R22 SERVICE LETTER SL-87

R44 SERVICE LETTER SL-73

SUBJECT: Main and Tail Gearbox Oil

ROTORCRAFT AFFECTED: All R22-series and R44-series helicopters.

FIGURE 1

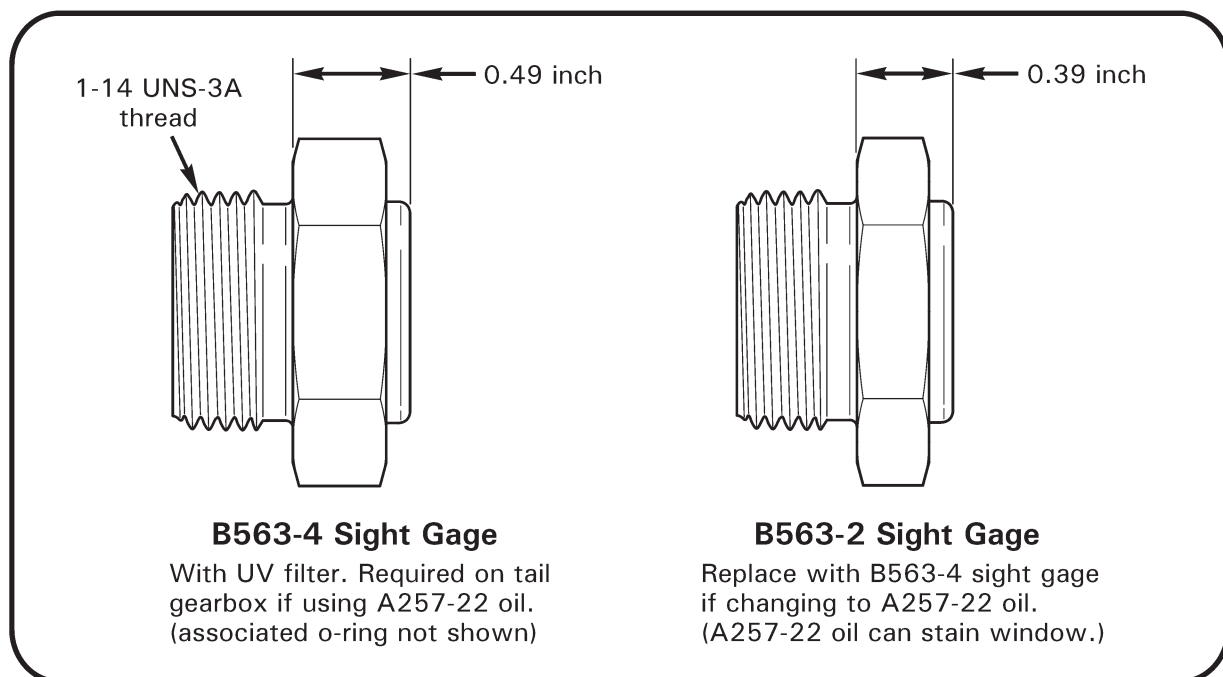
1. All R22 & R44 gearboxes (including new) may use A257-2 (traditional, blue) oil if more convenient or desired. Drain and flush per Maintenance Manual (MM) if converting from A257-22 oil.
2. Tail gearboxes are eligible for A257-22 oil provided a B563-4 sight gage is installed (refer to Figure 1); not all tail gearboxes can be retrofitted with the B563-4 sight gage (due to thread differences).
3. A006 R22 main gearboxes with A146-1 Revision Q & subsequent pinion are eligible for A257-22 oil. A146-1 pinion data plate is adjacent A006 gearbox data plate.
4. C006 R44 main gearboxes with C146-2 Revision Q & subsequent pinion are eligible for A257-22 oil. C146-2 pinion data plate is adjacent C006 gearbox data plate.
